**STAFF REPORT:** 9/13/2023 MEETING

**APPLICATION NUMBER:** HDC2023-00054

**ADDRESS:** 400 FISKE

**SCOPE OF WORK:** REPLACE SLATE ROOF WITH ASPHALT SHINGLES (WORK PARTIALLY COMPLETE)

**400 Fiske, current appearance of rear wall/roof. Staff photo taken 9/8/2023. Note that a new rubberized roof membrane is proposed for installation at the flat portion of the mansard roof at this location.**

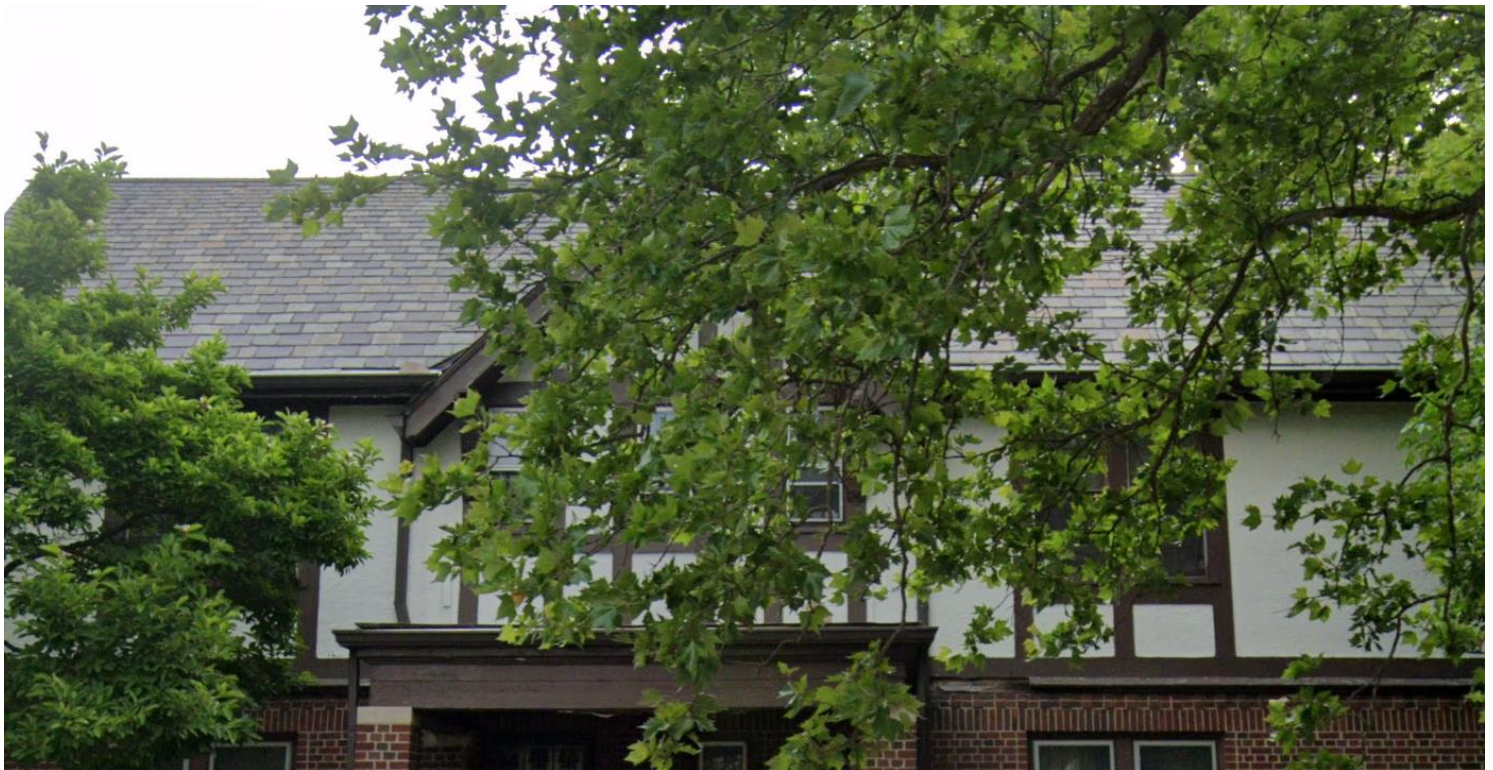
- The current scope of work calls for the addition of a new rubberized roof membrane on the flat portion of the rear mansard roof. Staff supports approval of this portion of the project

It is staff’s opinion that the proposal to install a new rubberized roof membrane at the flat portion of the rear mansard roof conforms to the district’s Elements of Design and meets the SOI standards. Staff therefore recommends that the Commission approve this scope item with the condition that the existing slate at the rear mansard roof be retained.
